**INVER GROVE HEIGHTS
PLANNING COMMISSION AGENDA**

**Tuesday, February 20, 2018 – 7:00 p.m.
City Council Chambers - 8150 Barbara Avenue**

3.03 INDUSTRIAL EQUITIES, LLP - CASE NO. 18-09PUD

Consider a **Preliminary Plat and Preliminary PUD Development Plan** for a one lot plat to construct a 95,250 square foot industrial warehouse building for the property identified as 20-29300-00-010.

1 SITE PLAN
A-1
SCALE: 1" = 30'

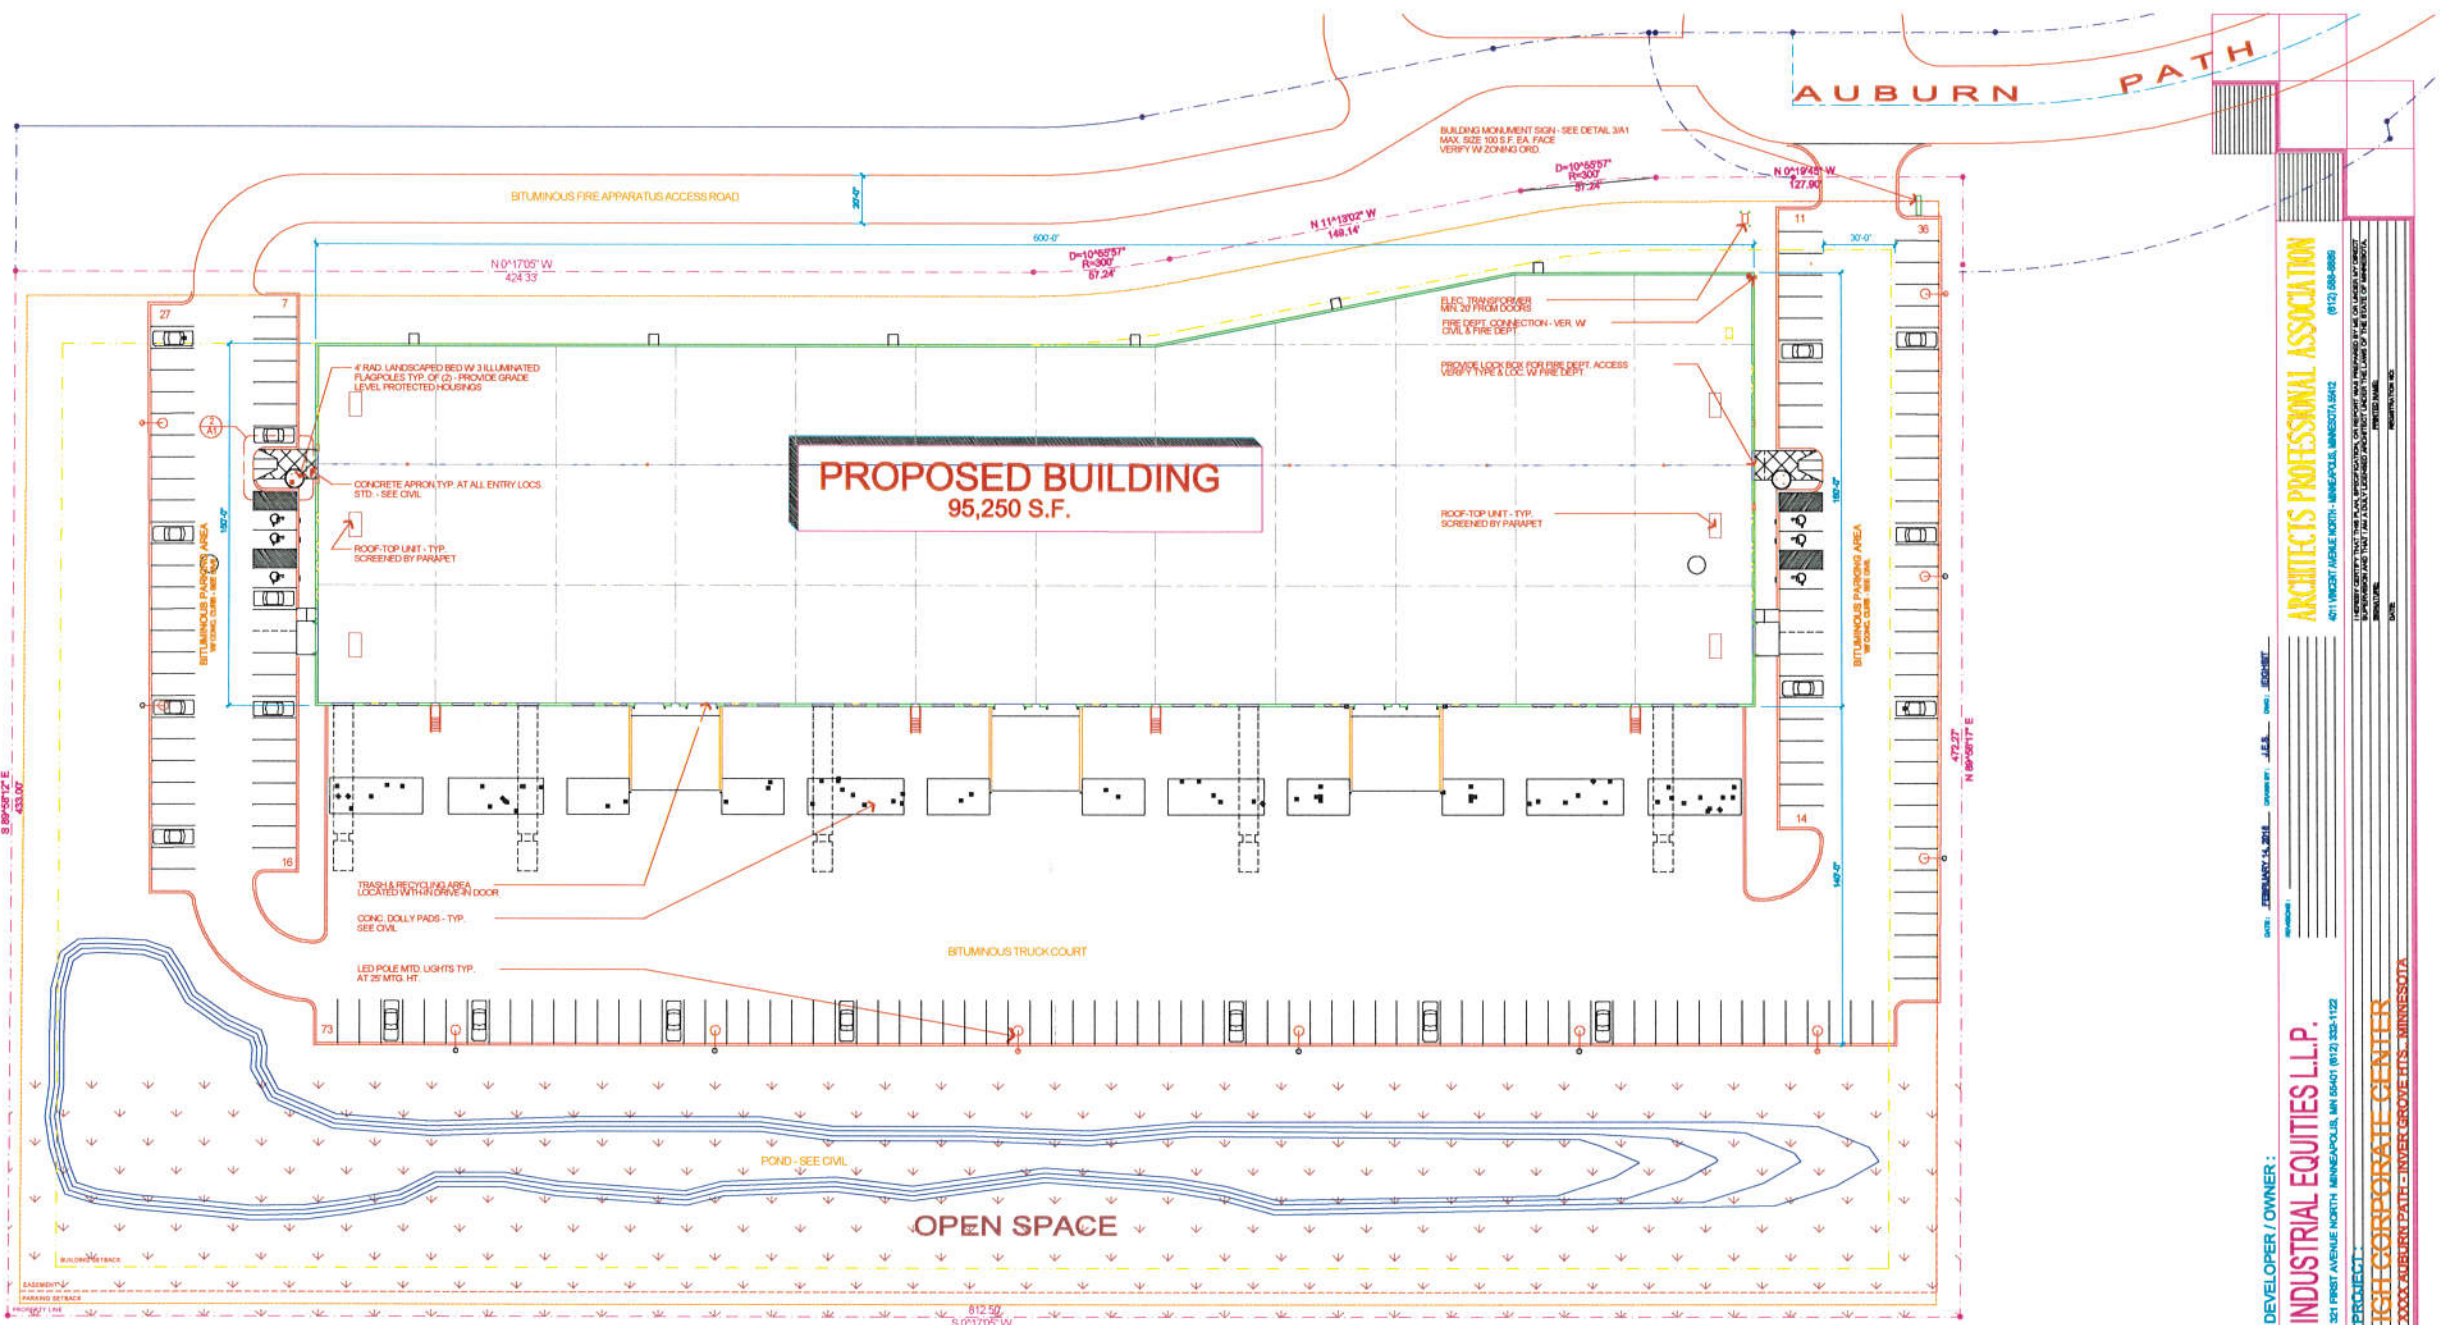
The plan provides two access points on the north and south ends of the site. The proposed plan assumes the outlot with the road easement would not be necessary and the property could be then utilized as a private driveway.

A determination should be made at this point whether the extension of Auburn Path should be built as a public street at this time, or if the road should not be extended and allow the easement to be vacated and access to the site would be by a private access driveway. Staff is requesting Planning Commission to make a recommendation on this issue with this request. The City Council should also make a final determination on this issue with this request.

Combining the two requirements, a total of 331 trees or, the equivalent of, is required for the proposed development. The applicant is proposing a total of 249 trees. The plan is short 82 trees. Either the plan must be modified to meet the requirement, or the remaining plantings must be either planted off site or payment to the tree replacement fund. If no additional trees can be placed on the property, the City Council shall determine the option.

Ordinance requires screening along properties zoned for residential. The plan provides for a number of trees along the north boundary to provide for the required screening.

The landscape plan must be modified to remove any trees within the 30 foot wide area for the future County Trail.

The plan provides for landscaping within the existing outlot with the road easement. If this is to become a public street, then the landscape plan must be modified to remove all trees out of this area.

8. As part of the final plan submittal, the landscape plan shall either be modified to provide for all necessary tree reforestation on site, or Council approve the shortage with off-site plantings or cash contribution to the Tree Preservation fund.

9. As part of the final plan submittal, the landscape plan shall be modified to remove proposed plantings out of the 30 foot wide easement for the future county trail.
